BCA COMPLIANCE ASSESSMENT REPORT

Building Address	Level 3, 1 Garigal Road, Belrose
Report No.	3029
Report For	C2cglobal Pty Ltd
Report By	Greg Murrow
Title / Company	Director Murrow Consulting Pty Ltd
Date	21 May 2021

This report provides a Building Code of Australia (BCA) compliance assessment of the proposed office fitout of Level 3 in the existing multi-storey commercial building at 1 Garigal Road, Belrose, in relation to the proposed new works.

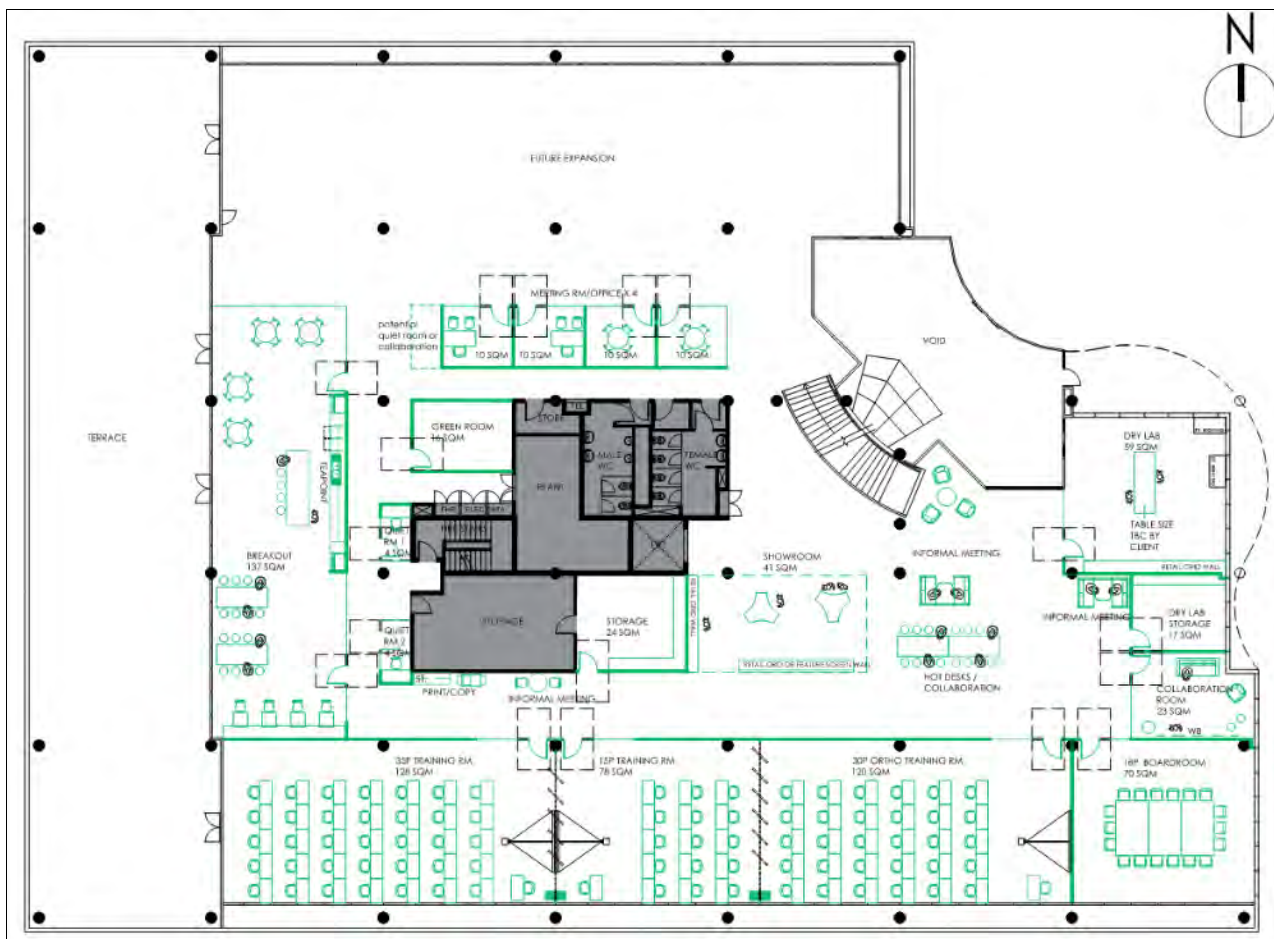
DTS Provision	Outline of DTS non-compliance	Recommendation to address DTS non-compliance
D1.4 Exit travel distances	The southwestern corner of the terrace is more than 20 m (is 27m) from a point from which travel in different directions to 2 exits is available – does not comply with D1.4(c)(i).	Design amendments or obtain a Performance Solution formulated in accordance with BCA Part A2.
E1.3 Fire hydrants	<u>Coverage:</u> Each internal fire hydrant shall have a single valve-controlled outlet and attack hydrant performance. Internal fire hydrants shall cover only the level on which they are located. All points on a floor shall be within reach of a 10 m hose stream issuing from a nozzle at the end of a 30 m length of hose laid on floor connected to the fire hydrant outlet. The hose shall extend a minimum length of 1 m into the area to which the fire hydrant is providing coverage.	To be confirmed.

F2.3 Facilities in Class 3 to 9 buildings	As per Table F2.3, the new Level 3 tenancy requires the following sanitary facilities numbers to accommodate the proposed population of 50 office employees: <ul style="list-style-type: none">• <u>Males (50):</u><ul style="list-style-type: none">○ WCs: 3 (2 provided – does not comply with Table F2.3);○ Urinals: 2 (2 provided – complies);○ Washbasins: 2 (2 provided considering the accessible unisex sanitary compartment washbasin counts once for each sex – complies);• <u>Females (37):</u><ul style="list-style-type: none">○ WCs: 4 (4 provided – complies);○ Washbasins: 2 (2 provided – complies).	Rely on the accessible unisex sanitary compartment on Level 2 for the additional male WC. To be confirmed.
